Groundwater Application Review Summary Form

Application # G- 19462

PUBLIC INTEREST REVIEW FOR GROUNDWATER APPLICATIONS

TO: Water Rights Section Date 6/20/2025
 FROM: Groundwater Section James Hootsmans
 Reviewer's Name
 SUBJECT: Application G- 19462 Supersedes review of _____
 Date of Review(s)

Water-Level Measurements in Nearby Wells (8S2W Sec 1)

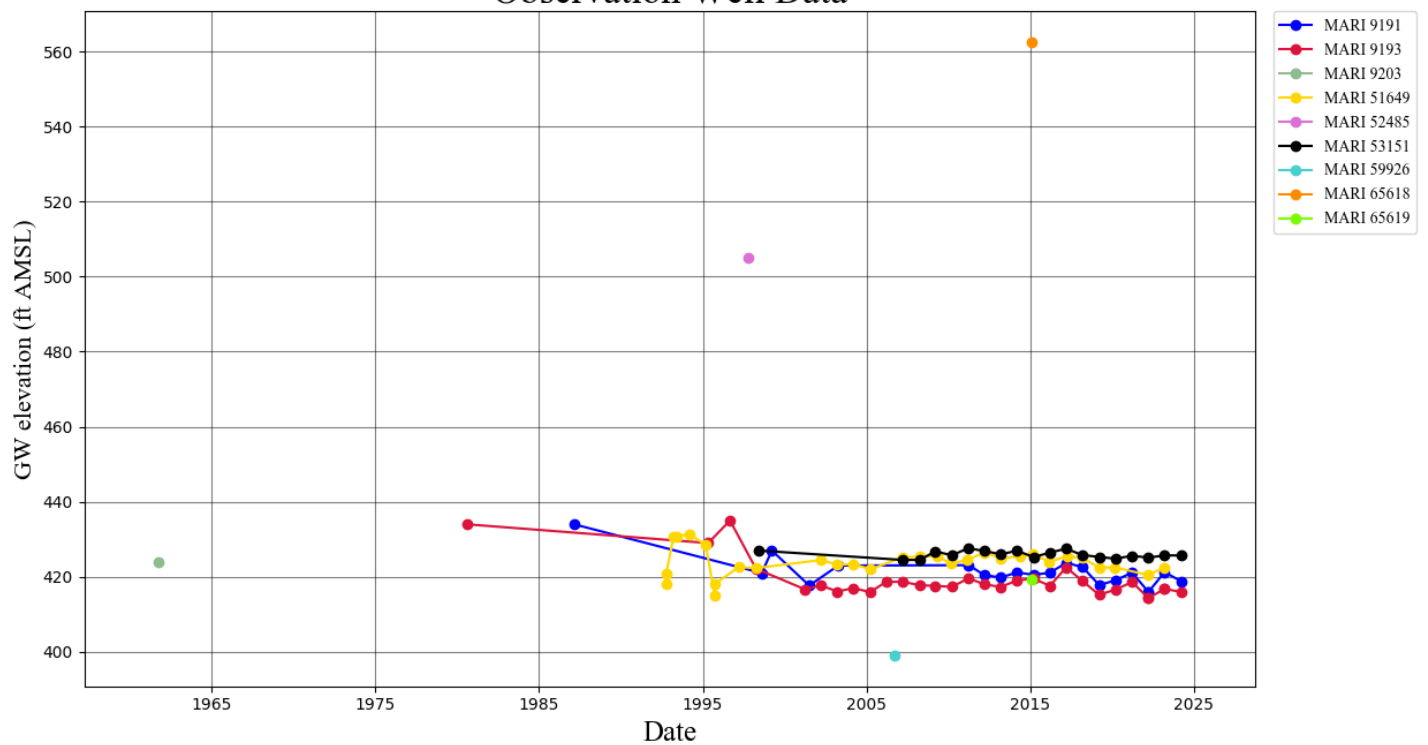
develop in the alluvial aquifer system above the CRBG. Water levels in the basalt wells appear to be stable, therefore, groundwater for the proposed is determined to not be over appropriated at this time.
